Re: *PennEast Pipeline Company, LLC*, Docket No. CP15-558-000
Comments on Draft Environmental Impact Statement

PennEast Pipeline Project

Draft Environmental Impact Statement Comments

Docket No. CP15-558-000

FIGURE NUMBER: **FIGURE 1B**

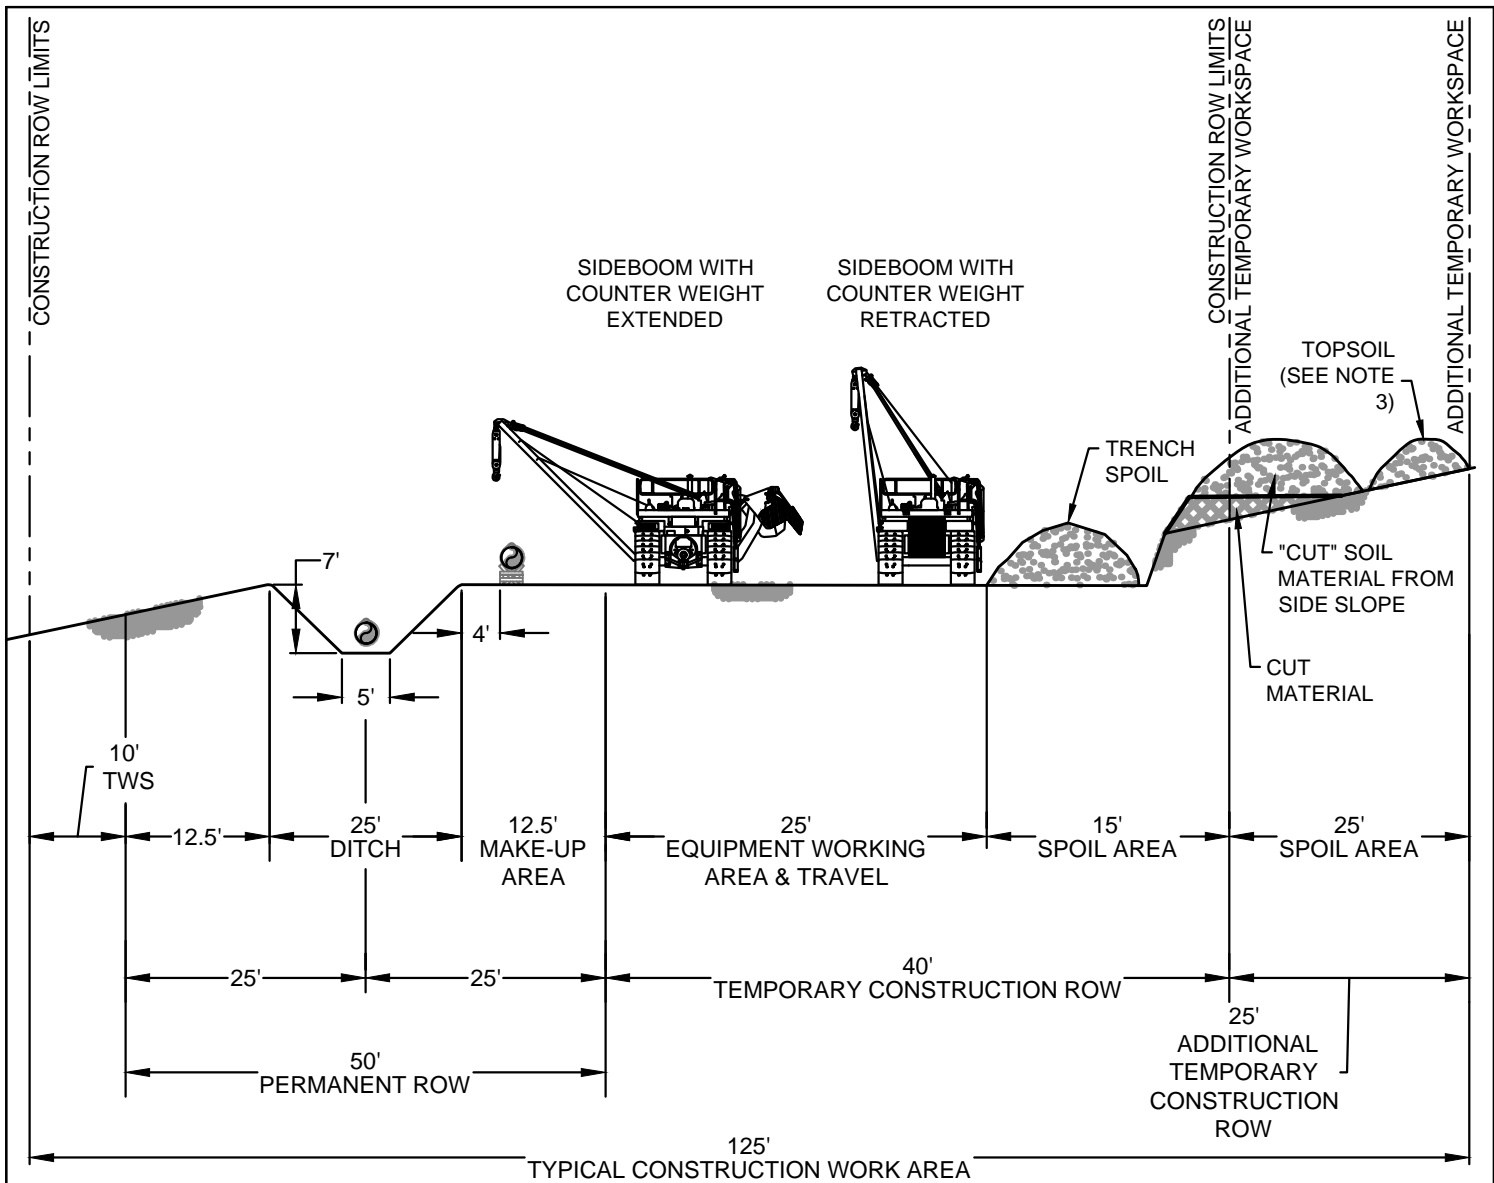
DEIS Section	Page No.	Paragraph/ Table/ Figure No.	Text	Comment	Suggested Resolution
			relatively minor overall. However, some long-term cumulative impacts would occur on wetland and forested vegetation and associated wildlife habitats. Water resources could potentially be negatively impacted by arsenic released by blasting activities associated with multiple projects.”		However, some long-term cumulative impacts would occur on wetland and forested vegetation and associated wildlife habitats. Water resources could potentially, but will unlikely, be negatively impacted by arsenic released by blasting activities associated with multiple projects (see Section 4.1.5.5).”
Appendix C	N/A	Figure 1B	Typical Upward Side Slope Workspace Construction Area	Workspace measurements were incorrect in the Typical Drawing included in the DEIS.	Replace Figure 1B with the revised Figure 1B, provided herein as part of Attachment 3.

FIGURE NUMBER: **FIGURE 1C**

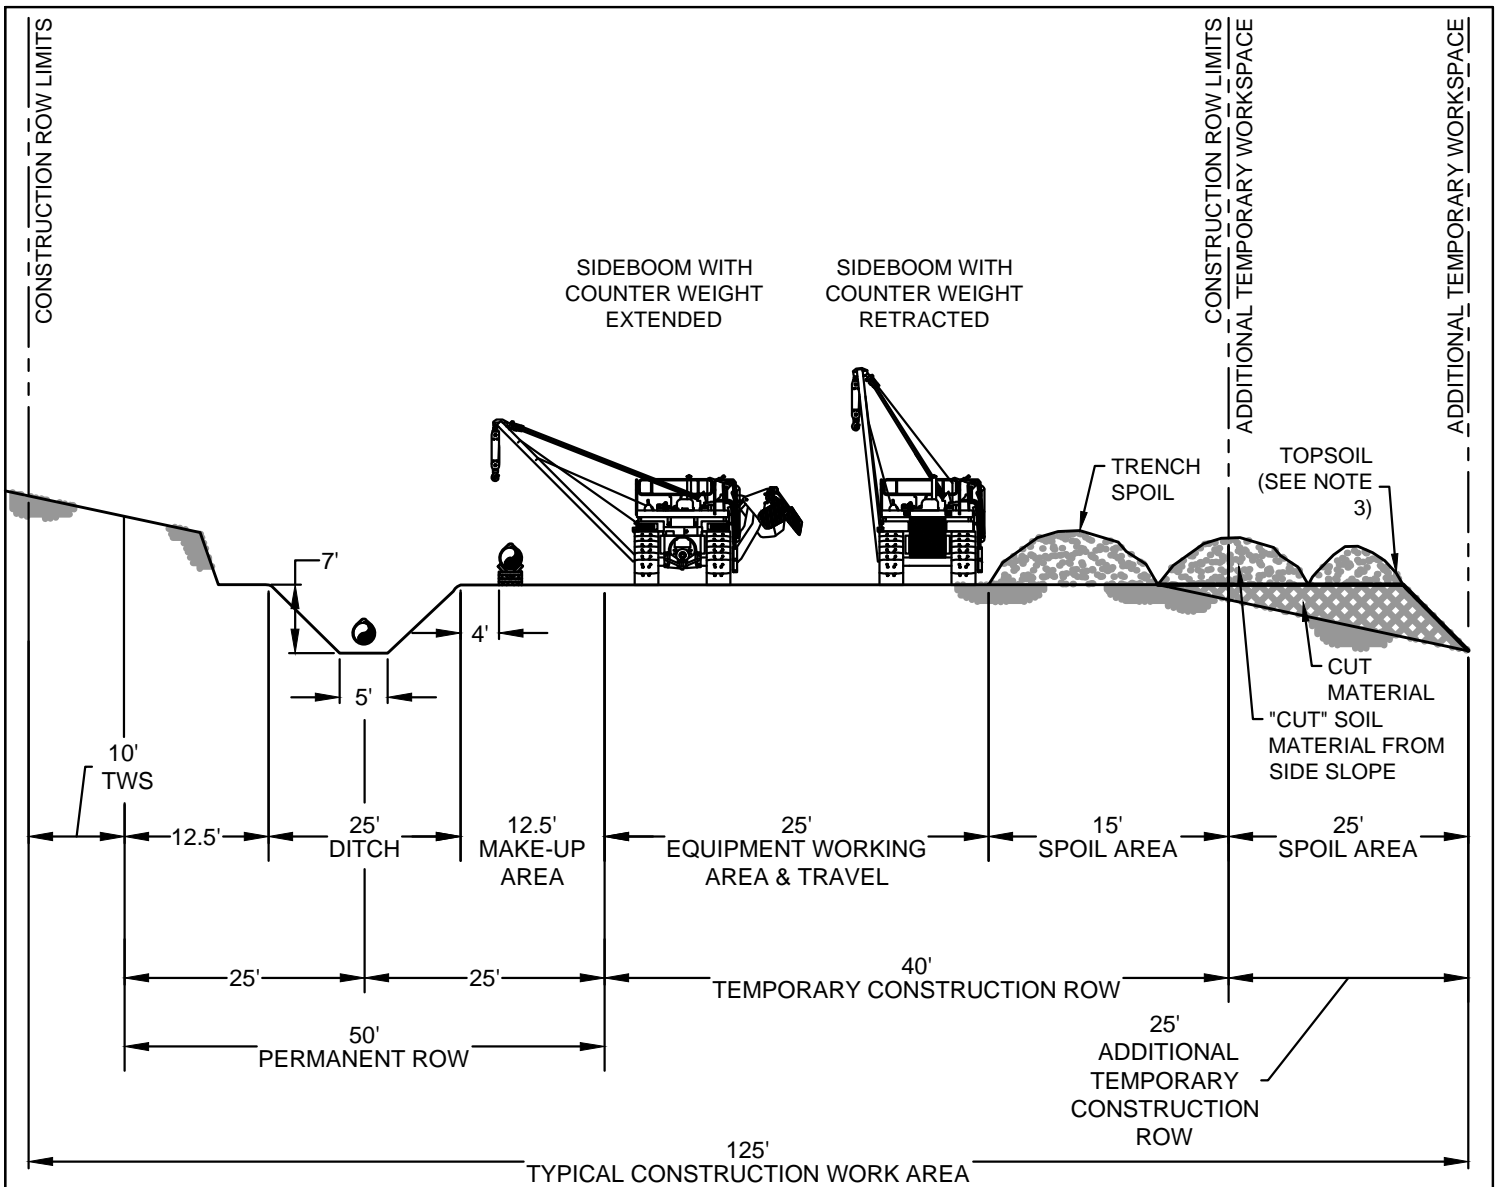
Appendix C	N/A	Figure 1C	Typical Downward Side Slope Workspace Construction Area	Workspace measurements were incorrect in the Typical Drawing included in the DEIS.	Replace Figure 1C with the revised Figure 1C, provided herein as part of Attachment 3.
Appendix E	N/A	Section 1.0, 1 st bullet	“114 miles of new 36-inch diameter mainline pipeline...”	The Project will consist of 115.1 miles of pipeline.	Change “114 miles” to “115.1 miles.”
Appendix E	N/A	Section 1.0, 3 rd bullet	“0.6-miles of new 12-inch diameter lateral...”	The Gilbert Lateral will be 0.1 mile.	Change “0.6-miles” to “0.1-mile.”
Appendix E	N/A	Section 1.0, 4 th bullet	“1.4-miles of new 36-inch diameter lateral...”	The Lambertville Lateral will be 1.5 miles.	Change “1.4-miles” to “1.5-miles.”
Appendix E	N/A	Earthquake Probability, 1 st paragraph	“A seismic disturbance is any earth movement (natural or manmade) that is caused by a momentary disturbance of the elastic equilibrium of a portion of the earth. URS conducted a seismic hazard evaluation to evaluate the potential seismic hazard of the 114 mile long Project area...”	The proposed Project mainline will be 115.1 miles.	Change “114 mile long” to “115.1 miles long.”
